Woollahra Local Planning Panel (Public Meeting)

Thursday 5 September 2024
1.00pm

LOCAL PLANNING PANEL SECTION 4.56 APPLICATION ASSESSMENT REPORT

ITEM No.	D1
FILE No.	DA436/2020/2
ADDRESS	18 Olphert Avenue Vacluse
COUNCIL WARD	Vacluse
ZONING	R2 Low Density Residential
EXISTING CONSENT	The demolition of an existing dwelling house and the construction of a new dwelling house and swimming pool and associated works
DATE OF CONSENT	29/11/2022
TYPE OF CONSENT	Local development
CONSENT AUTHORITY	Land and Environment Court
PROPOSED MODIFICATION	Modifications to the levels of the approved rear yard area/ swimming pool, landscaping and fencing modifications
TYPE OF MODIFICATION	Section 4.56
DATE S4.55 LODGED	02/01/2024 - original lodgement 18/07/2024 - amended application
APPLICANT	Ms S J Curtis
OWNER	Mr C D Taylor & Ms S J Curtis
AUTHOR	Mr D Booth
TEAM LEADER	Mr M Moratelli
SUBMISSIONS	7 to the original application 5 to the amended application
RECOMMENDATION	Conditional approval

4.56_3
RAISED POOL REV 2
ELEVATIONS NORTH

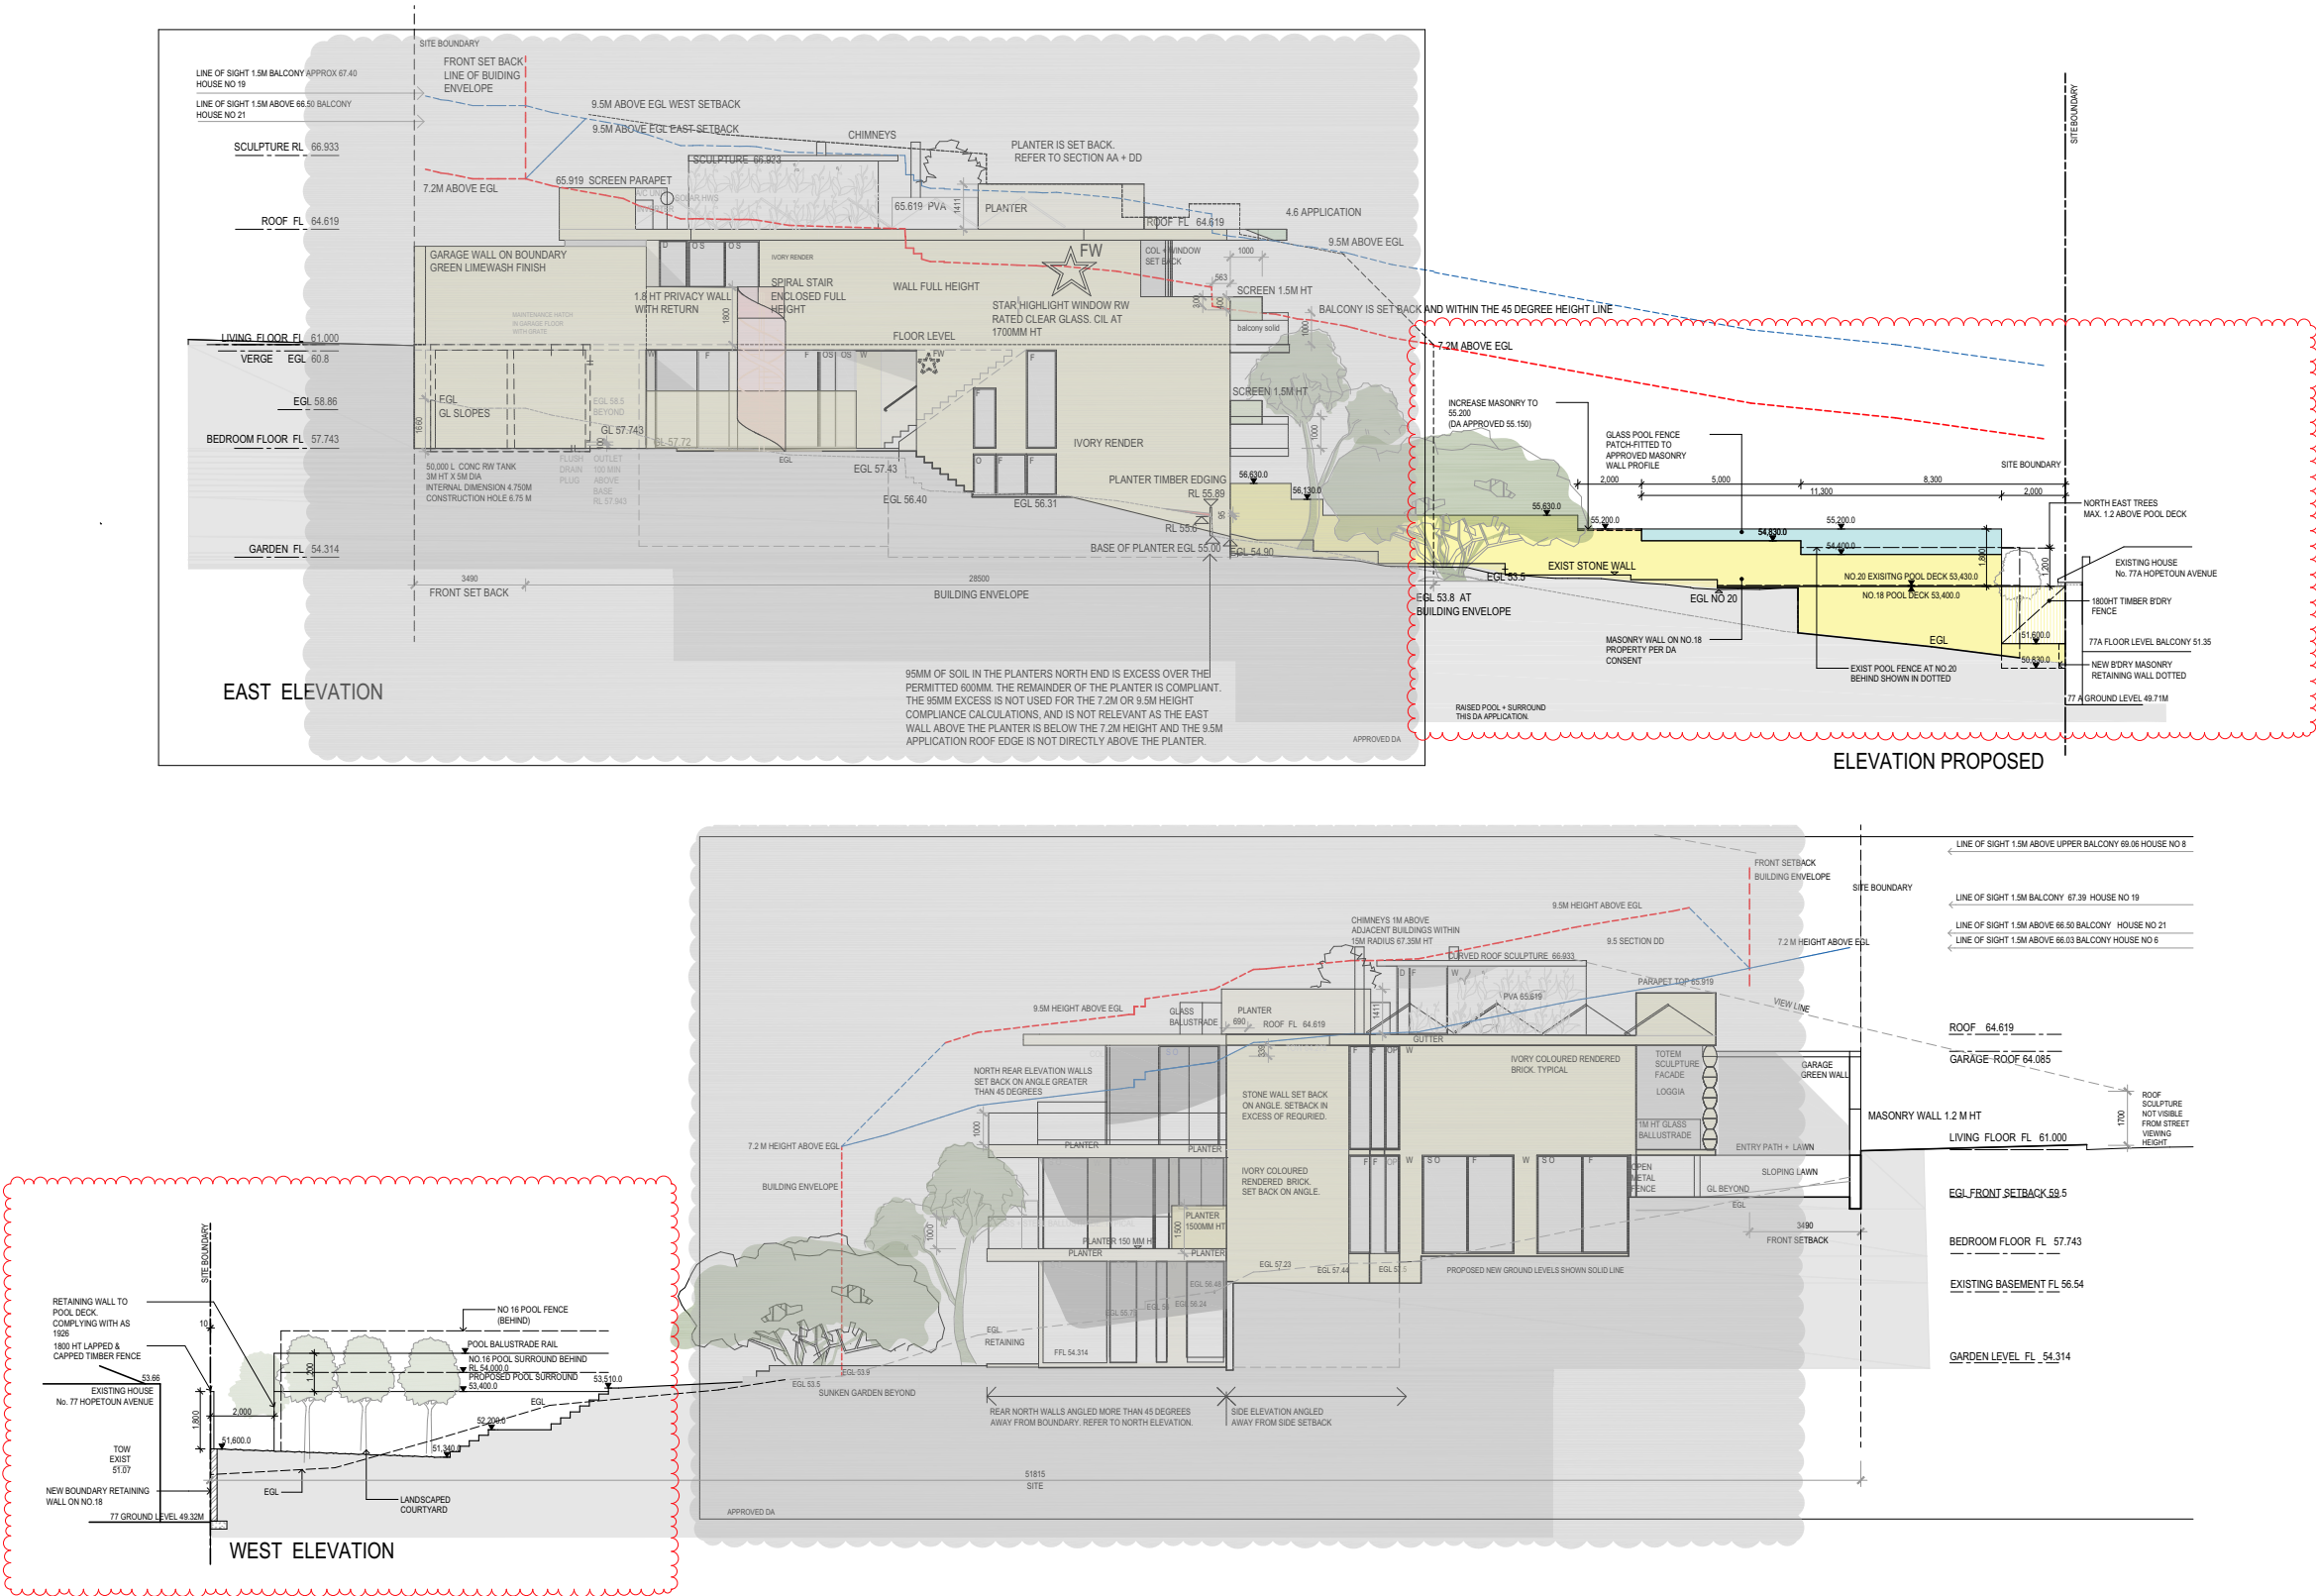
- *Drawing 4.56 2.1 references "No. 20 masonry retaining wall" and such is also documented on drawing 4.56 3 Section L with the subject eastern boundary pool fence butting up against it and is relied upon to retain the proposed additional fill to the swimming pool surround. The retaining wall does not exist and landowners' consent is not granted for the construction of a retaining wall on 20 Olphert Avenue.*

- *Drawing 4.56 3 Section L does not accurately document the approved swimming pool as it has a hump in the middle to avoid the sewer line/ the cross sections inaccurately document base of the approved pool*

Whilst drawing 4.56 3 Section L and the cross sections incorrectly document the approved pool base, it is considered that nothing turns on this. It is the documentation of the proposed pool base and the 600mm sewer clearance that is of significance.

The incorrect documentation of the approved eastern boundary masonry wall and the retaining wall on the 20 Olphert Avenue side of the common boundary incorrectly documented drawing 4.56 3 Section L is addressed by recommended **Condition C.1f**.

- f) Where the eastern boundary pool wall/ fence is inconsistently documented on drawings 4.56 2.1 & 3.1 compared with drawing 4.56 3 Section L, the documentation on drawings 4.56 2.1 & 3.1 prevail.

4.56_3.1
RAISED POOL REV 2
ELEVATIONS
EAST WEST

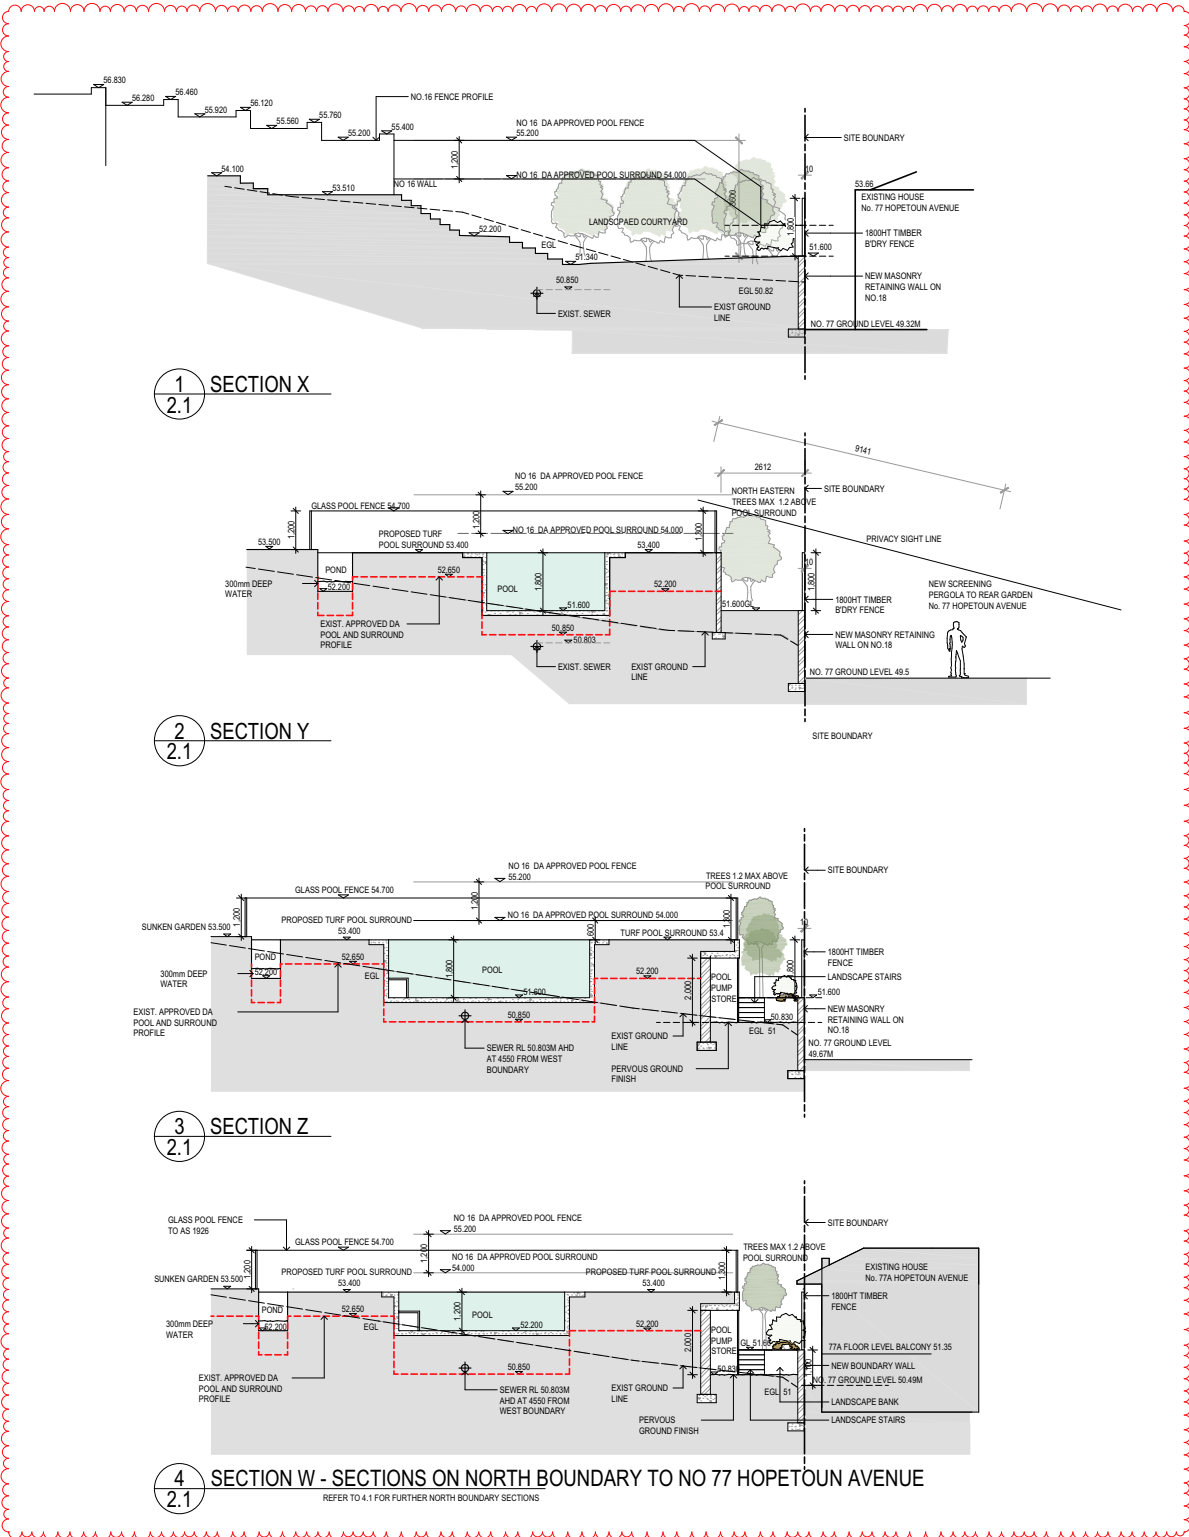
The eastern side elevation documents that the raised mature plant height would be 200mm higher than the approved eastern side boundary wall which is not considered to be significant in terms of imparting amenity impacts upon the adjoining property including view impacts.

4.56_4
RAISED POOL REV 2
CROSS SECTIONS

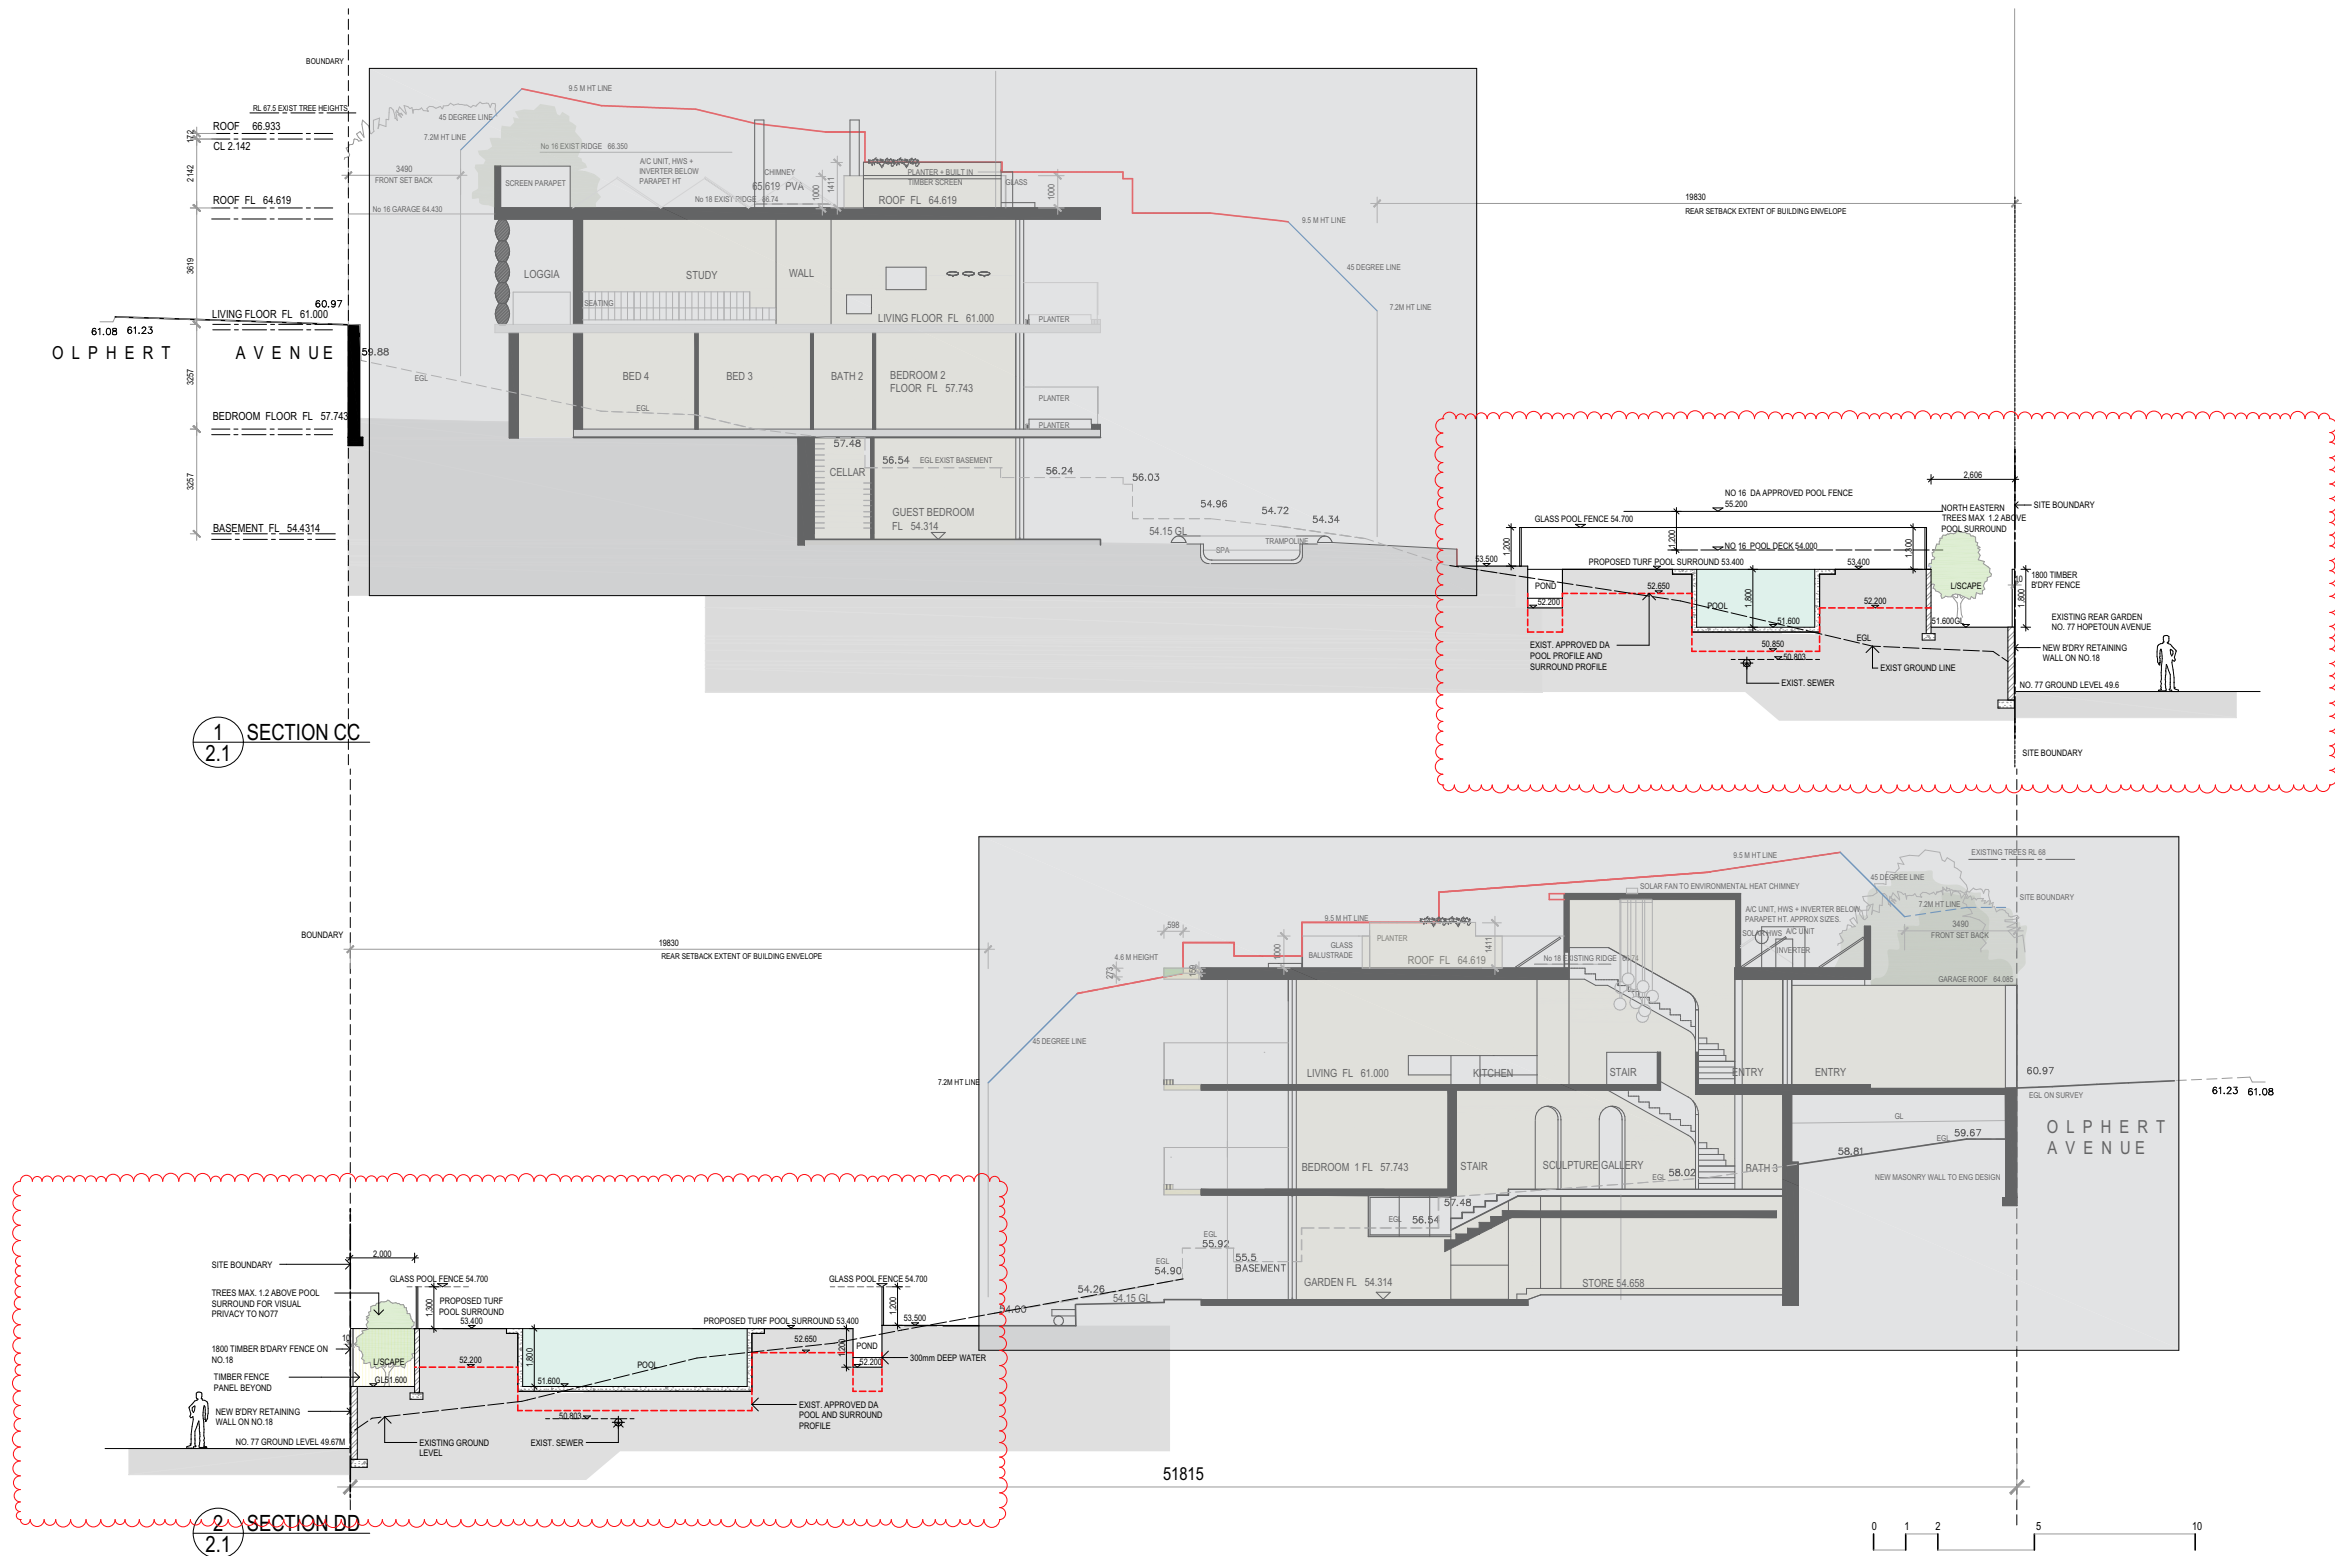
The inconsistent documentation of the spa on drawing 4.56_4.1 Section CC is addressed by recommended **Condition C.1g**.

- g) Where the deletion of the approved spa/ addition of an infiltration system is inconsistently documented on drawing 4.56_2.1 Garden Floor plan compared with drawing 4.56_4.1 Section CC, the documentation on drawing 4.56_2.1 Garden Floor plan prevails.
